Engineering revision handoff

Engineering file ID 23.2 | SR1 builds on E1

23.2 SR1 adds mechanical switch retention following version 26's split-cage and removable-clamp principle. Version 26 itself is unchanged and was not requalified.

Walkie One 23.2 | SR1 mechanical switch capture

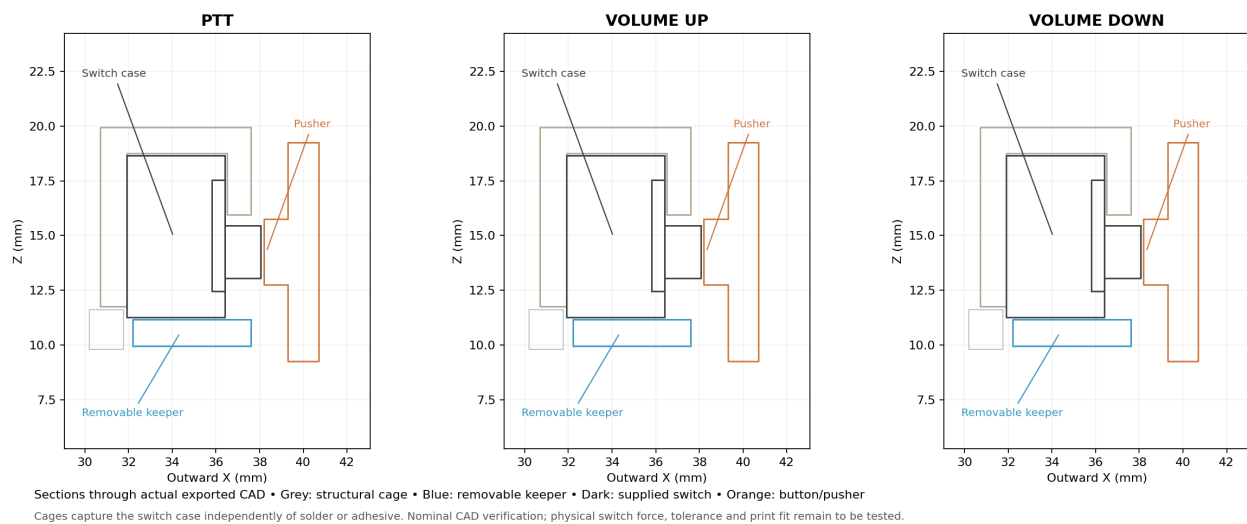
Side-button gaps are nominally 0.14 mm, with modeled stops at 0.65 mm. Check actual switch limits and tolerances; these values do not certify allowable overtravel. See the front-switch sections in the package for the retained front interfaces.
